# Sub Regional RTEP Committee: Western Dayton Supplemental Projects

April 21, 2023

# Changes to the Existing Supplemental Projects

**S2695** : Need Number: Dayton-2021-011 - Needs Meeting 12/17/2021, Solutions Meeting 2/18/2022, posted to 2022 Dayton Local Plan

➤ **Octa Substation**

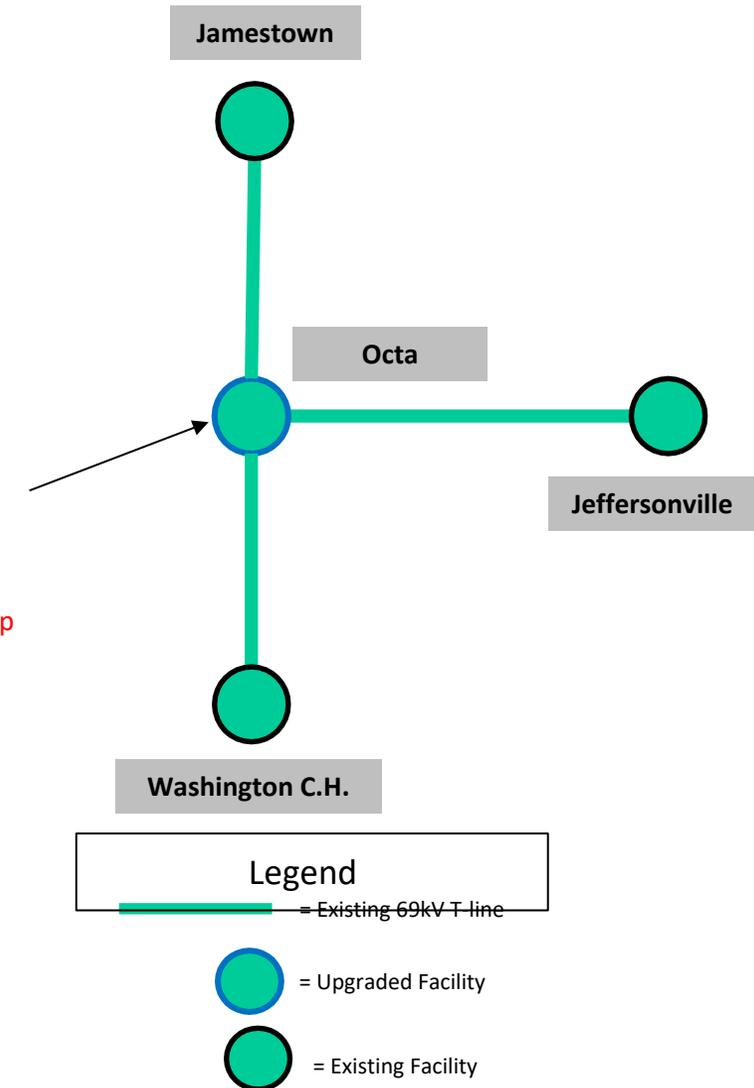
- A new 69/12kV transformer will be installed at Octa Substation and terminated into a new 69kV breaker position. This will expand Octa Substation from a three breaker 69kV ring bus to a four breaker 69kV ring bus. This transformer will create a new delivery point for AES Ohio distribution. This delivery point will provide capacity and switching flexibility, particularly at the Washington Courthouse and Jeffersonville substations, ensuring load can be restored under contingency conditions.
- **Install a 30MW cap bank to support the voltage profile and improve operational flexibility due to area development and the large load addition in Jeffersonville**

➤ **Estimated cost** :- ~~\$310K~~ **\$0.71M**

➤ **Projected In-Service:** ~~12/31/2023~~ **06/30/2026**

- Addition of a 69/12kV transformer and circuit breaker at Octa Substation
- **Addition of a 30MW cap bank**
